Lawrence G. Dunbar, P.E.
Water Resources & Environmental Engineer/Consultant
Firm Reg. No. F-5214
6342 Dew Bridge Drive
Sugar Land, TX 77479
281-980-2225

Re: Litigation on the Closure of Rollover Pass – Impacts on Dredging of the GIWW

1. Overview of the Corps' EA and Statement of Findings re: permit Application by GLO for the closing of Rollover Pass

Figure 1B. Computed volumes of sediment accumulation in GIWW (Volume is in cubic feet). To convert to cubic meters, multiply cubic feet by 0.30483

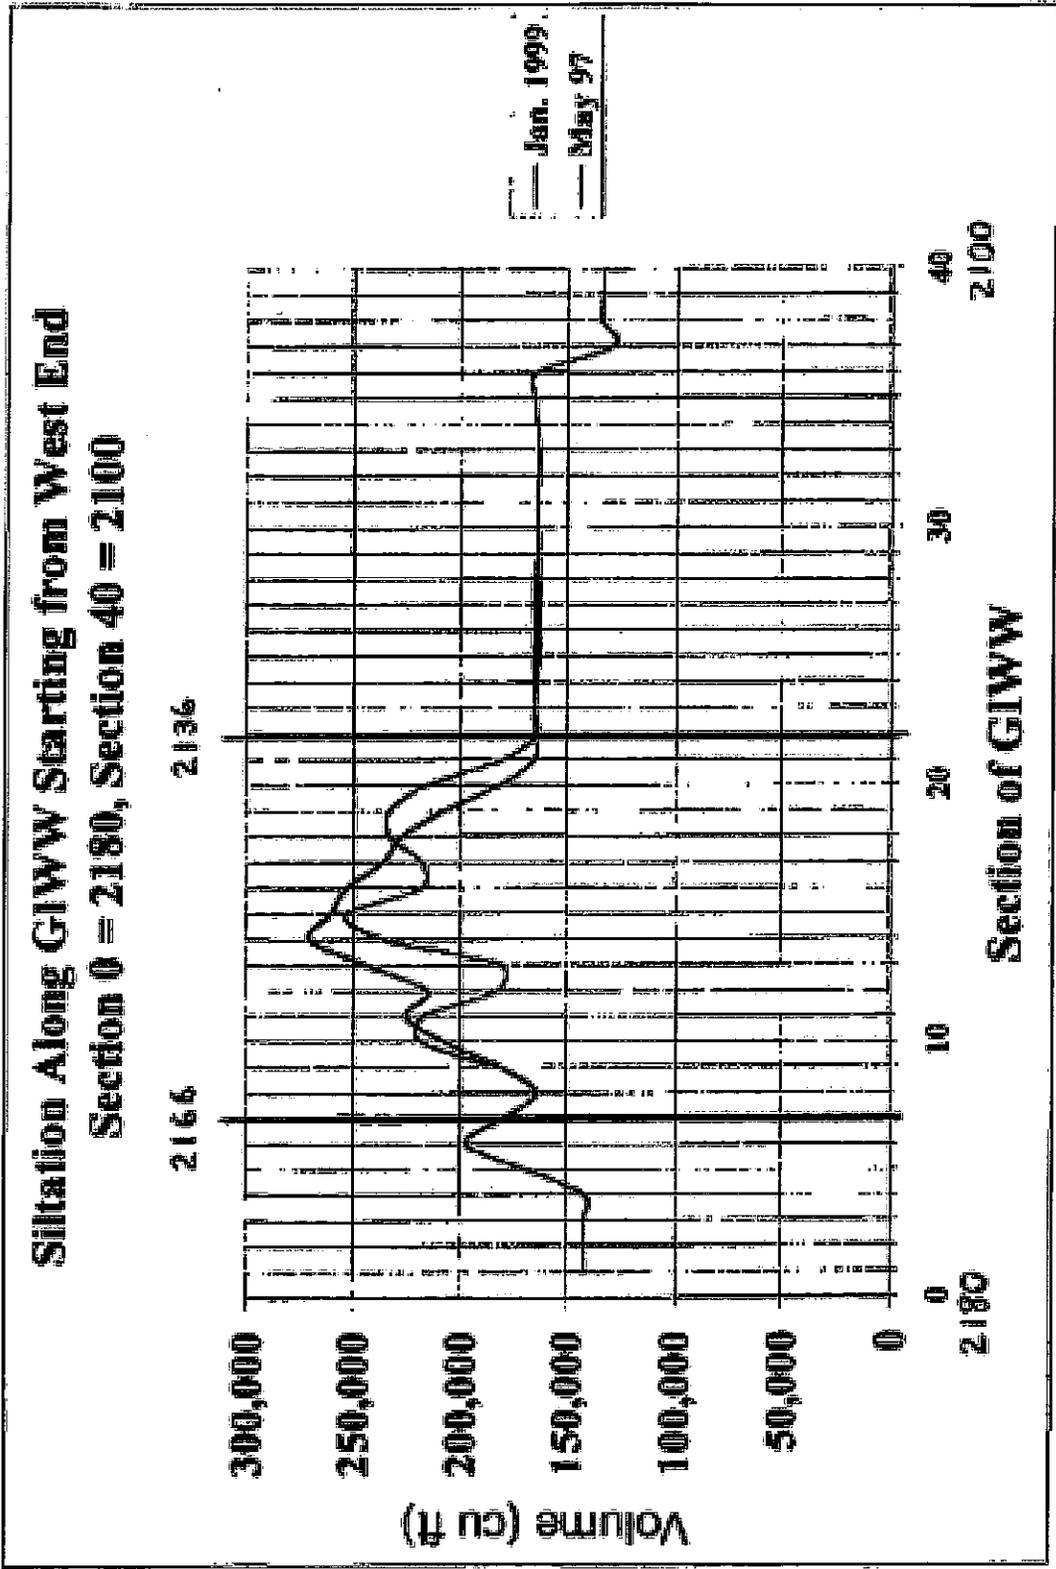
Pass from the GOM and into the GIWW. [Table 5 of ERDC study – COE000669]. Table 5 from this ERDC study shows the excess siltation in this reach of the GIWW where the coarser sand was found for the two dredging periods analyzed (1997 and 1999). This 15,000 cy/yr estimate is consistent with the estimate provided by Taylor Engineering in its study regarding the results of the ERDC study (i.e. 15,400 cy/yr); however, Taylor Engineering did not present any discussion in its report to the GLO regarding this ERDC study and how its estimate of excess siltation was derived, nor did it present any of the ERDC study findings as to the extent of the reach where sediment was found within the GIWW that was attributable to the Pass. **Exhibit A** herein is a copy of Figure 17 from the ERDC study showing the various stations designated along the GIWW by the Corps of Engineers. The 3,000-foot reach, determined by the ERDC as being where sediment with coarser sand was found, covered stations 2136+00 through 2166+00, a distance of 0.57 miles. **Exhibit B** herein is a copy of Figure 18 from the ERDC study showing the volume of sediment accumulation in the various reaches of the GIWW through Rollover Bay and East Bay. I have shown on this exhibit where the 3,000-foot reach is located (between Stations 2136 and 2166), in which the increased sediment accumulation as compared to other portions of the GIWW is clearly evident.

Figure 1 Observed Mean and Extreme Intracoastal Waterway Dredging Rates, Station 1700+00 to Station 2700+00, 1943-1980 (Source: Bales and Holley, 1989)

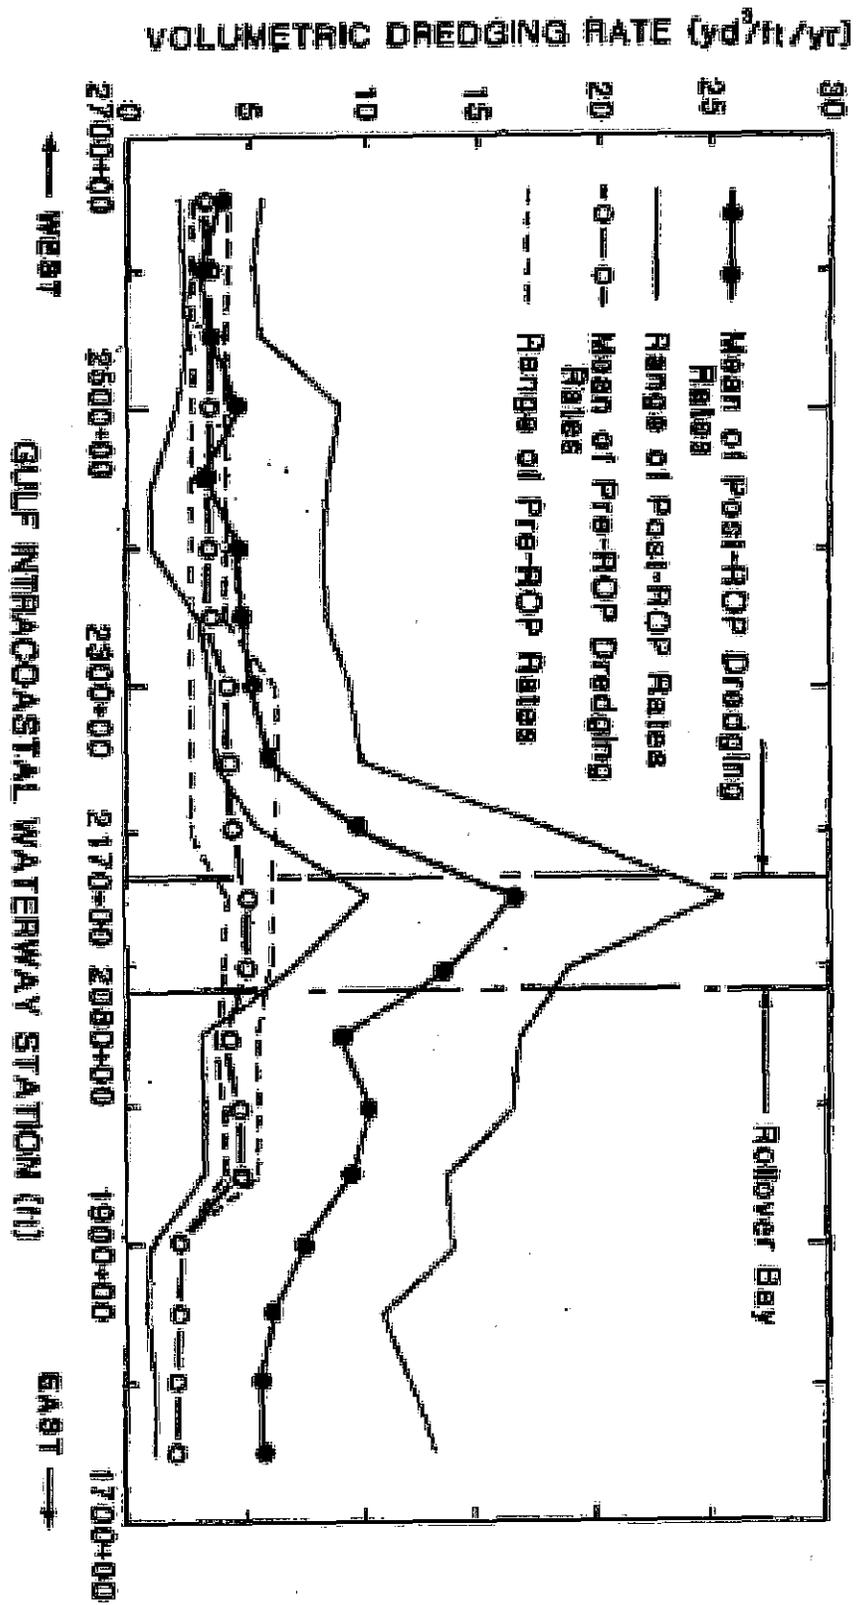
amounts shown in the attached Exhibit C (Figure 1 of the 1989 Bales and Holley study) within the GIWW as compared to pre-Pass conditions is evident within Rollover Bay (Stations 2170+00 – 2080+00) and east thereof, and to a lesser extent east of East Bay (east of Station 1900+00). This increase in sedimentation along this reach of the GIWW is expected since the velocities in the GIWW are going to decrease as flows coming from the east enter the reach where East Bay begins (Station 1900), since there is more area for these flows to pass through, thereby lowering their velocities. Lower velocities allow sediments suspended in the water to settle out into the bottom of the GIWW channel. As this water travels further west, it enters Rollover Bay (Station 2080), where there is even more area for the flows to pass through, thereby producing even lower velocities in the GIWW, thereby allowing even more sediment to settle out and deposit into the GIWW channel.

This explains the differing amounts of dredged material shown in Exhibits B and C along the various reaches of the GIWW, and why assigning all of the sediment found in the GIWW to sediment transported through the Pass is an invalid assumption not supported by the data collected by the Corps' ERDC. Instead, based on the proper understanding of the data presented, the sediment transported through the Pass and being deposited into the GIWW has been on the order of about 10,000 - 15,000 cy/yr.
